In the Drawings

REMARKS

FIG. 4D

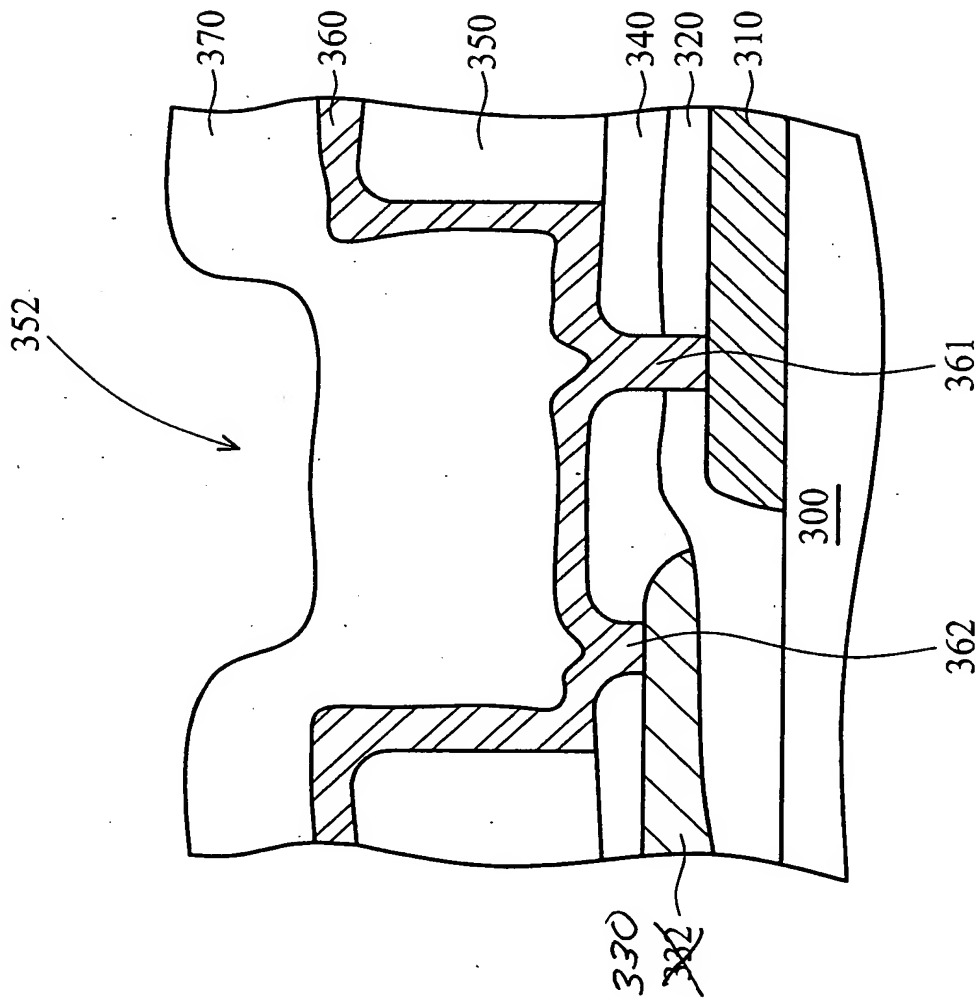
In FIG. 4D, “ 332” is changed to “ 330,” as shown in the accompanying annotated drawing sheet.
